ADDENDUM No. 8
TO THE
CITY OF FRESNO
PUBLIC WORKS STANDARD DRAWINGS AND SPECIFICATIONS
ADOPTED MARCH 4, 1970, BY RESOLUTION NO. 70-36

THIS UPDATED VERSION IS APPROVED: JANUARY 30, 2023

Addendum 8 to the Public Works Standard Drawings and Specifications, dated January 30, 2023

RESIDENTIAL STREET WITH
WEDGE CURBS

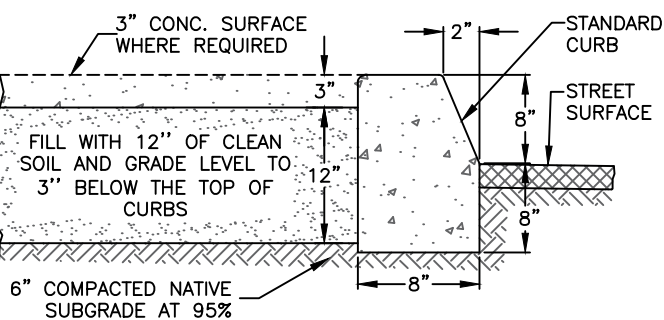
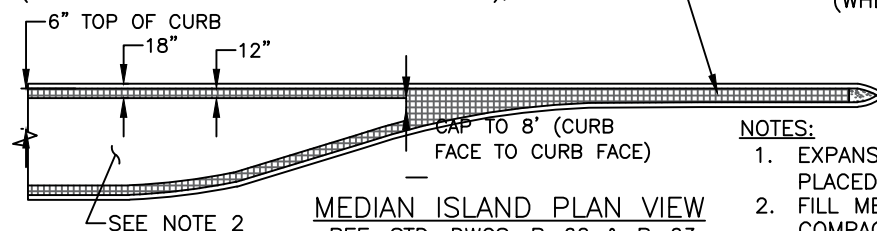
DPW – PUBLIC WORKS	
P-9	<ol style="list-style-type: none">1. Clarified/edited dimensions for “Residential Streets with Wedge Curbs”.2. Reduced sidewalk width by 1’-0” and added “1’-0” Clear” to detail: “Residential Streets with Wedge Curbs and Adjacent Sidewalks”.
P-31	<ol style="list-style-type: none">1. Ramp revised to graphically show grade breaks perpendicular to the path of travel to comply with ADA requirements and expectations.2. Added Note 14: “GRADE BREAKS AT THE TOP AND BOTTOM OF CURB RAMP RUNS SHALL BE PERPENDICULAR TO THE DIRECTION OF THE RAMP RUN. GRADE BREAKS SHALL NOT BE PERMITTED ON THE SURFACE OF RAMP RUNS AND TURNING SPACES. SURFACE SLOPES THAT MEET AT GRADE BREAKS SHALL BE FLUSH.”3. Dimension: “5’ MIN.” moved to back of ramp.4. Dimension: “6’ MIN.” revised to read: “6.5’ MIN.”5. Added dimension: “3’ MIN.” behind truncated domes.6. Callout: “OPTIONAL: 12” GROOVED BORDER PER P-28, SEE NOTE 14, THIS SHEET” revised to read: “OPTIONAL: SEE NOTE 5”7. Callout: “POST-MOUNTED PEDESTRIAN PUSHBUTTON (WHEN NEEDED), SEE NOTES 11 & 12” revised to read: “POST-MOUNTED PEDESTRIAN PUSHBUTTON (WHEN NEEDED), SEE NOTES 12 & 13”8. Callout: “SEE NOTES 4 & 5” revised to read: “SEE NOTES 1 & 6”.

DOME PATTERN

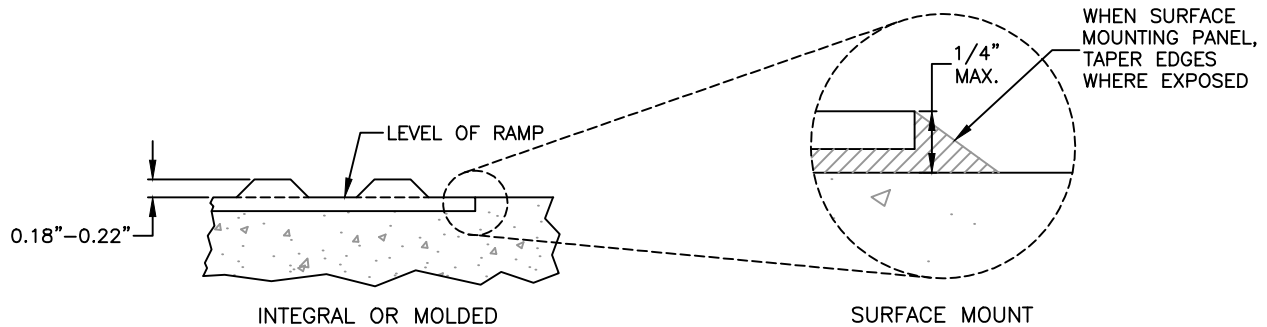
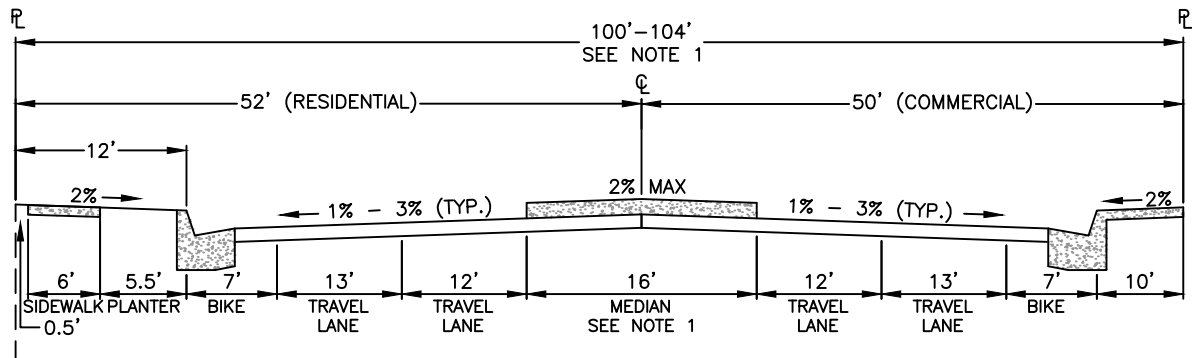
P-32	<ol style="list-style-type: none">1. Note 1: “THE DETECTABLE WARNING SHALL VISUALLY CONTRAST PER THE CALIFORNIA BUILDING CODE, LATEST REVISION. THE MATERIAL USED SHALL BE AN INTEGRAL PART OF THE WALKING SURFACE. THE COLOR SHALL BE YELLOW UNLESS DIRECTED OTHERWISE BY CONSTRUCTION MANAGEMENT.” revised to read: “THE DETECTABLE WARNING SHALL VISUALLY CONTRAST PER THE CALIFORNIA BUILDING CODE, LATEST REVISION. THE MATERIAL USED SHALL BE AN INTEGRAL PART OF THE WALKING SURFACE. THE COLOR SHALL BE YELLOW AND APPROXIMATE FS 33538 OF SAE AMS-STD-595A.”
P-52	<ol style="list-style-type: none">1. Incorporated Note 3 into Note 1: “USE 26’ MEDIAN WHEN DUAL LEFT TURNS ARE REQUIRED”, revised to read: “USE 26’ MEDIAN WIDTH WHEN DUAL LEFT TURNS ARE REQUIRED. USE OF A 22’ MEDIAN IS ALLOWED ONLY WHEN AN ARTERIAL HAS BEEN SPECIFICALLY PLANNED FOR A 22’ MEDIAN ISLAND.2. Note 2: “OFFSET CROWN REQUIRES APPROVAL OF THE ENGINEER DEVIATIONS FROM STANDARDS REQUIRE APPROVAL OF THE ENGINEER.” revised to read: “USE OF AN OFFSET

1. THE DETECTABLE WARNING SHALL VISUALLY CONTRAST PER THE CALIFORNIA BUILDING CODE, LATEST REVISION. THE MATERIAL USED SHALL BE AN INTEGRAL PART OF THE WALKING SURFACE. THE COLOR SHALL BE YELLOW AND APPROXIMATE FS 33538 OF SAE AMS-STD-595A.

CASE 1: DIVIDED ARTERIAL — NO PARKING

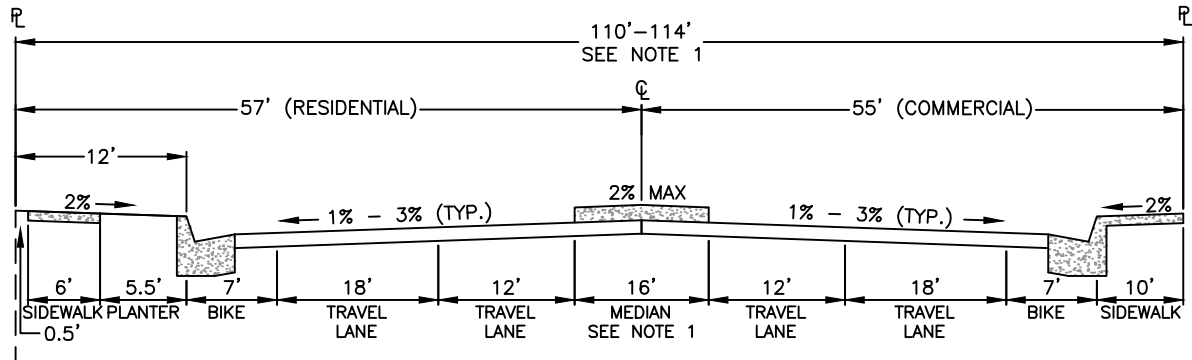
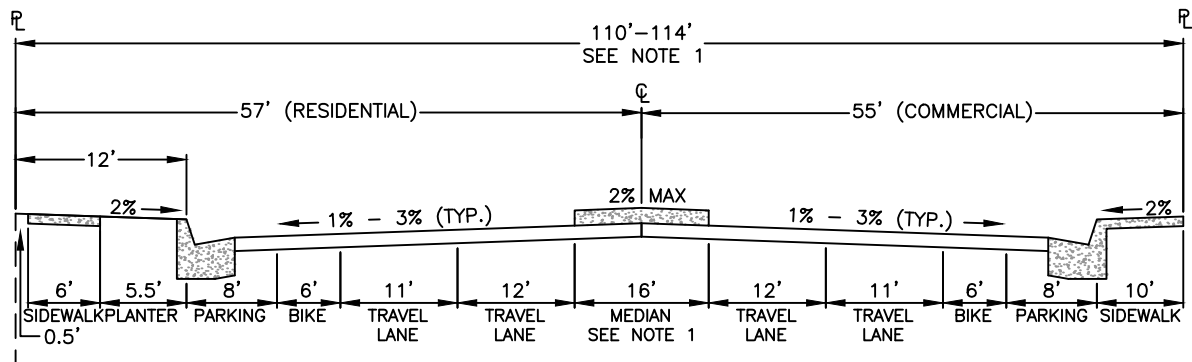
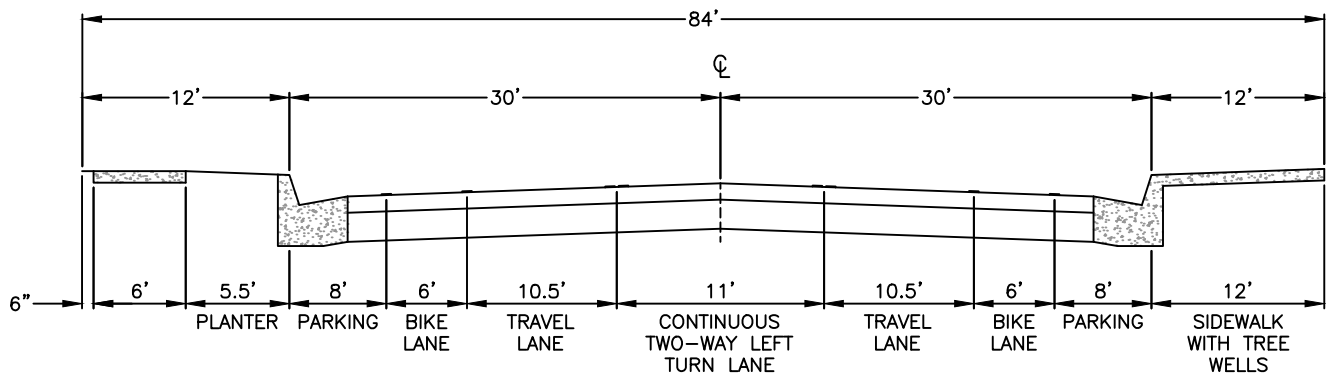
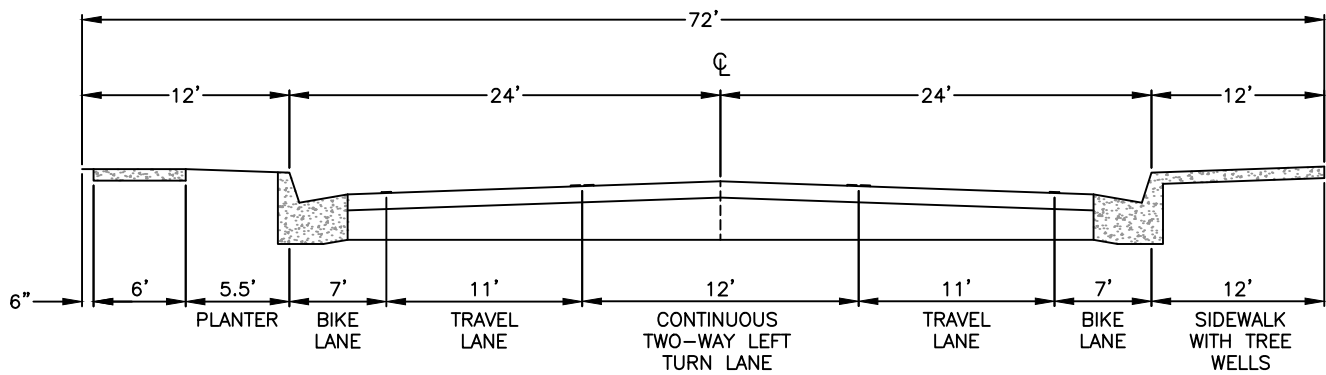
<p>CROWN OR OTHER DEVIATIONS FROM THIS STANDARD REQUIRES PRIOR APPROVAL OF THE CITY TRAFFIC ENGINEER.”</p> <ol style="list-style-type: none"> 3. Note 3 removed. 4. Note 4 renumbered to Note 3. 5. Note 5 renumbered to Note 3 6. Case 1 Detail revised as follows: <ol style="list-style-type: none"> a. ROW width dimension: “100’ (106’)” revised to read: “100’-104’” b. Left half-street dimension: “50’” revised to read: “52’ (RESIDENTIAL)” c. Left sidewalk pattern dimension: “10’” revised to read: “12’” d. Left sidewalk width dimension: “4’” revised to read: “6’” e. Right half-street dimension: “50’” revised to read: “50’ (COMMERCIAL)” f. Median width dimension: “16’ (22’) MEDAIN” revised to read: “16’ MEDIAN SEE NOTE 1” 7. Case 2 Detail revised as follows: <ol style="list-style-type: none"> a. ROW width dimension: “110’” revised to read: “110’-114’” b. Left half-street dimension: “55’” revised to read: “55’ (RESIDENTIAL)” c. Left sidewalk pattern dimension: “10’” revised to read: “12’” d. Left sidewalk width dimension: “4’” revised to read: “6’” e. Left #2 travel lane dimension: “13’” revised to read: “18’” f. Right half-street dimension: “55’” revised to read: “55’ (COMMERCIAL)” g. Median width dimension: “16’ MEDAIN” revised to read: “16’ MEDIAN SEE NOTE 1” 8. Case 3 Detail revised as follows: <ol style="list-style-type: none"> a. ROW width dimension: “110’” revised to read: “110’-114’” b. Left half-street dimension: “55’” revised to read: “55’ (RESIDENTIAL)” c. Left sidewalk pattern dimension: “10’” revised to read: “12’” d. Left sidewalk width dimension: “4’” revised to read: “6’” e. Right half-street dimension: “55’” revised to read: “55’ (COMMERCIAL)” f. Bike lane dimensions: “5’” revised to read: “6’” g. #2 travel lane dimensions: “12’” revised to read: “11’” h. Median width dimension: “16’ MEDAIN” revised to read: “16’ MEDIAN SEE NOTE 1”

1. USE 26' MEDIAN WIDTH WHEN DUAL LEFT TURNS ARE REQUIRED. USE OF A 22' MEDIAN IS ALLOWED ONLY WHEN AN ARTERIAL HAS BEEN SPECIFICALLY PLANNED FOR A 22' MEDIAN ISLAND. ADDITIONAL RIGHT OF WAY IS REQUIRED FOR THE 22' OR 26' MEDIANS.
2. USE OF AN OFFSET CROWN OR OTHER DEVIATIONS FROM THIS STANDARD REQUIRES PRIOR APPROVAL OF THE CITY TRAFFIC ENGINEER.
3. CASE 2 SHALL ONLY BE USED FOR SHORT GAP FILLING BETWEEN EXISTING CASE 2 ARTERIALS.
4. CASE 3 SHALL NOT BE USED UNLESS APPROVED BY THE CITY TRAFFIC ENGINEER.

COLLECTOR STREET WITH PARKING
(2 TRAVEL LANES) 84' ROW

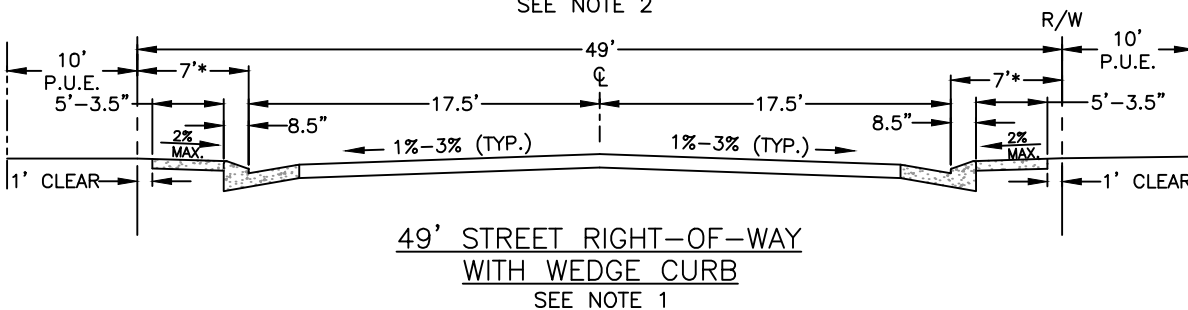
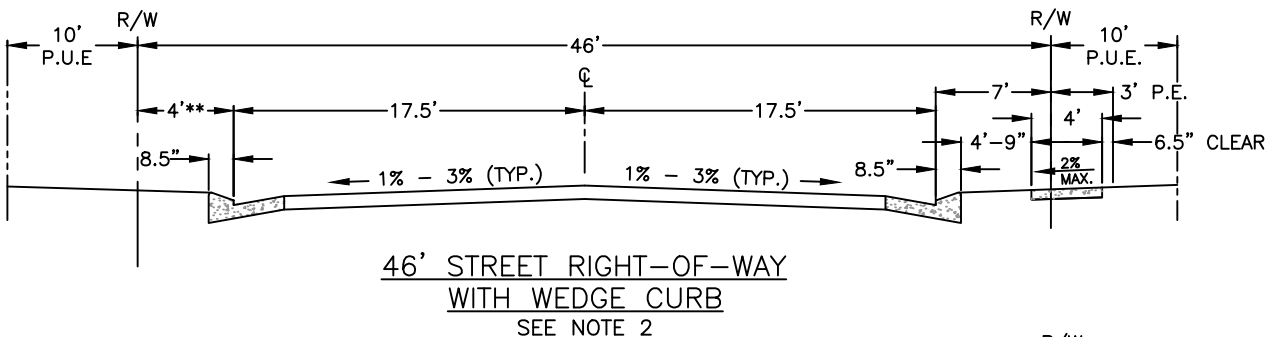
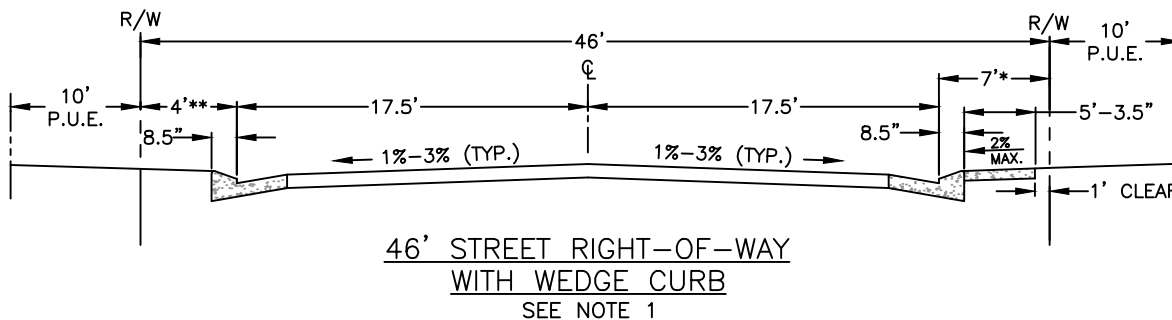
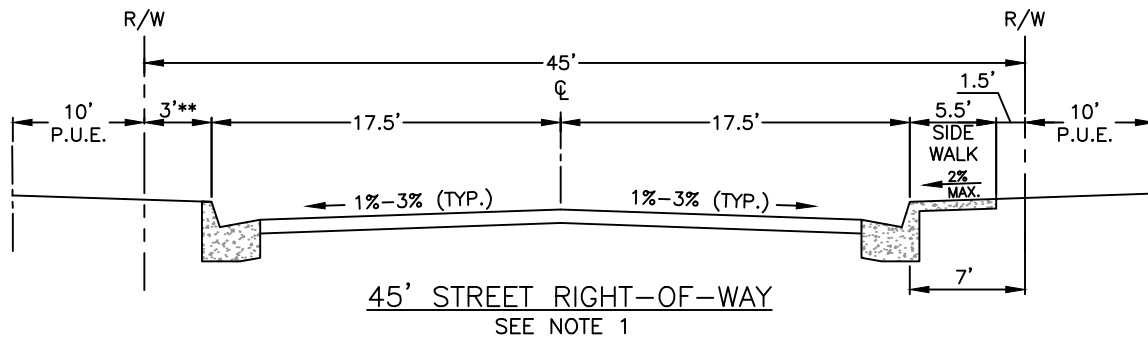
P-54	<ol style="list-style-type: none"> 1. Modified dimensions on “COLLECTOR STREET WITH PARKING” cross-section as follows: changed the bike lane width from 5’ to 6’ on both sides to comply with P-79 (Addendum 7). The two-way left -turn lane was reduced from 12’ to 10’ to provide the additional bike lane width. 2. Minor changes made to graphics and presentation.
P-56B	<ol style="list-style-type: none"> 1. Standard drawing title, “LOCAL STREET CROSS-SECTIONS (WITH WEDGE CURBS)” revised to read, “LOCAL STREET CROSS-SECTIONS ALTERNATIVE WIDTHS/WEDGE CURBS” 2. Modified detail dimensions to accurately reflect sidewalk pattern dimensions per Std. Det. P-9. 3. Supplemental note “ * “ revised to include reference to Std. Det. P-9. 4. Minor graphical edits for clarity.
P-71	<ol style="list-style-type: none"> 1. New Standard Drawing, “STANDARD PAVEMENT UNDULATION”.
P-72	<ol style="list-style-type: none"> 1. Renumbered to FAX-1. Refer to that Standard Drawing for additional details and changes in this Addendum.

BUS STOP WITH SHELTER LAYOUT PLAN

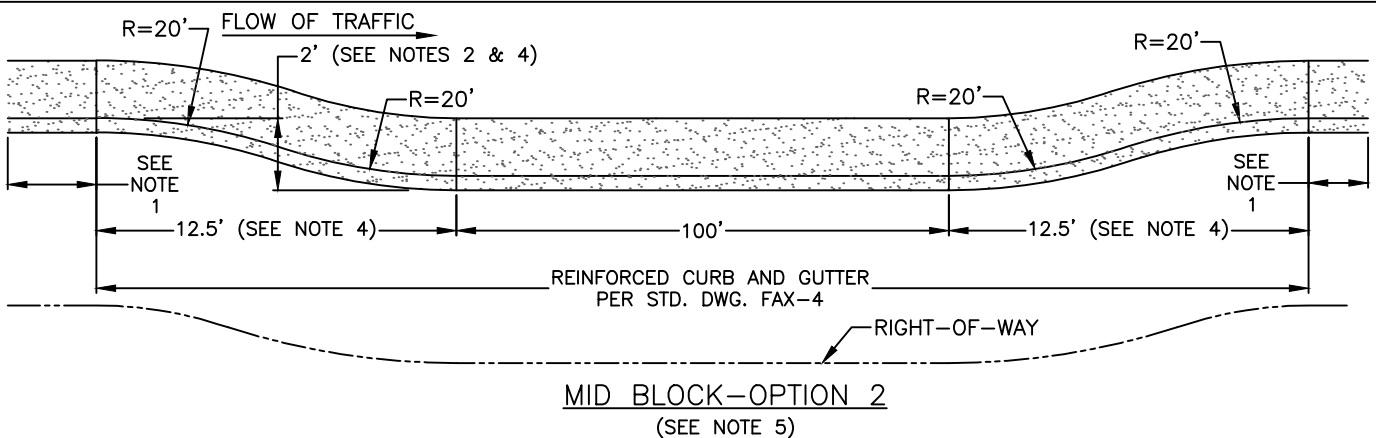
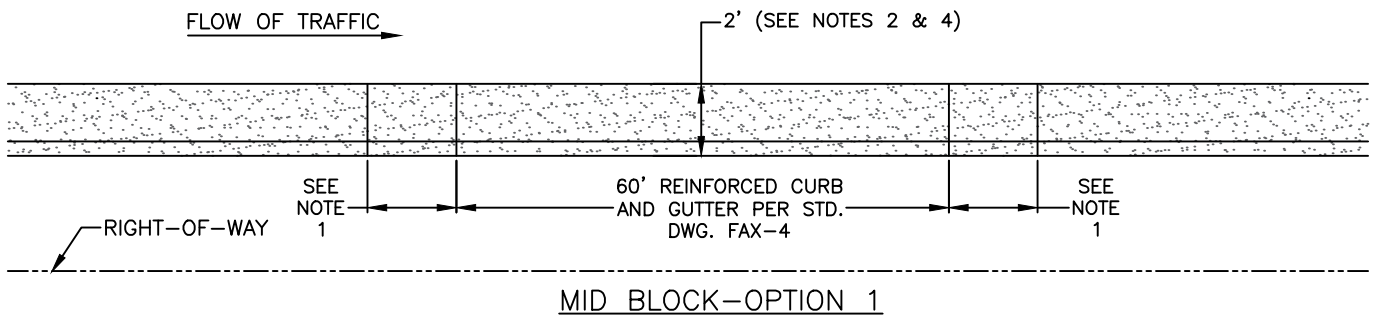
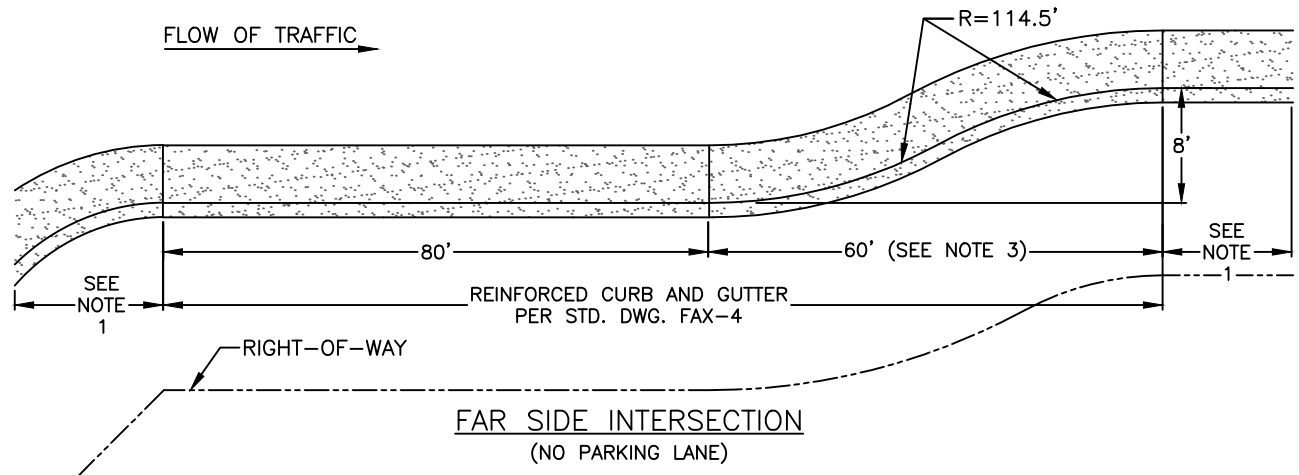
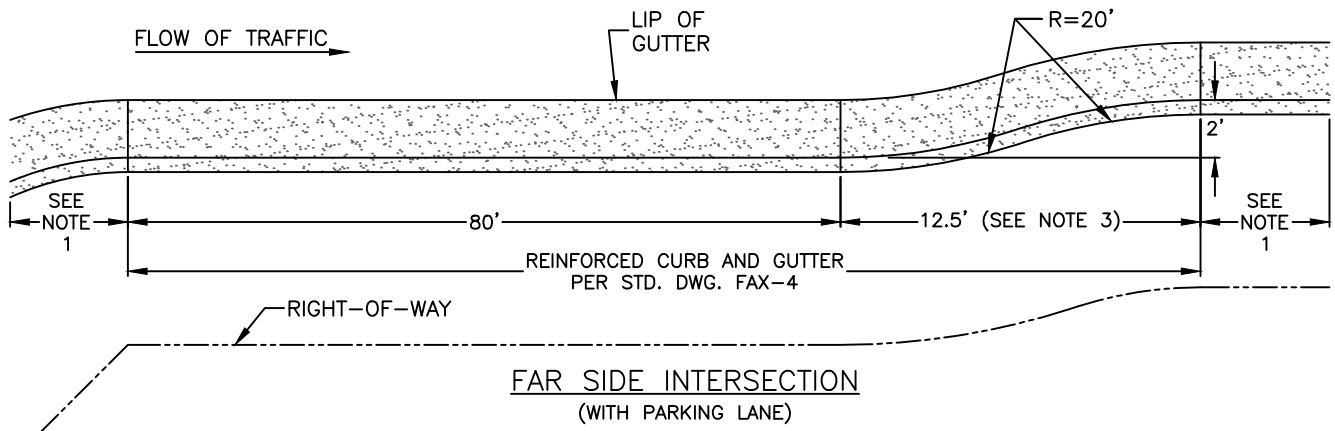
FAX – FRESNO AREA EXPRESS	
FAX-1	<ol style="list-style-type: none"> 1. New Standard Drawing based on P-72. 2. Drawing title changed from, “BUS STOP WITH SHELTER LAYOUT” to “BUS STOP WITH SHELTER LAYOUT PLAN”. 3. References to P-73 changed to reference FAX-3 or FAX-4, as appropriate. 4. Added callout, “2% CROSS SLOPE, MAX.” to bench area of plan view.
FAX-2	<ol style="list-style-type: none"> 1. New Standard Drawing based on P-73. 2. Reinforced curb and gutter “DETAIL” and construction notes #2 and #4 moved to Standard Drawing FAX-4. 3. The bus bay layouts were graphically modified to improve readability and reduce user confusion – no technical changes were made except as noted herein. 4. City ROW lines are shown in detail for orientation purposes. 5. Layout, “MID BLOCK” renamed: “MID BLOCK OPTION 2” 6. New layout, “MID BLOCK OPTION 1” added. 7. Note 3 renumbered to note 2 8. Note 5 renumbered to note 3 9. Note 6 renumbered to note 4 10. Added note #5, “USE WHEN TRAVEL LANE IS <20’ (LANE LINE TO FACE OF CURB). CITY ENGINEER MUST APPROVE USE.” 11. Dimension, “SEE BELOW FOR CURB & GUTTER IN THIS AREA” revised to read, “REINFORCED CURB AND GUTTER PER STD. DWG. FAX-4”. Multiple occurrences.
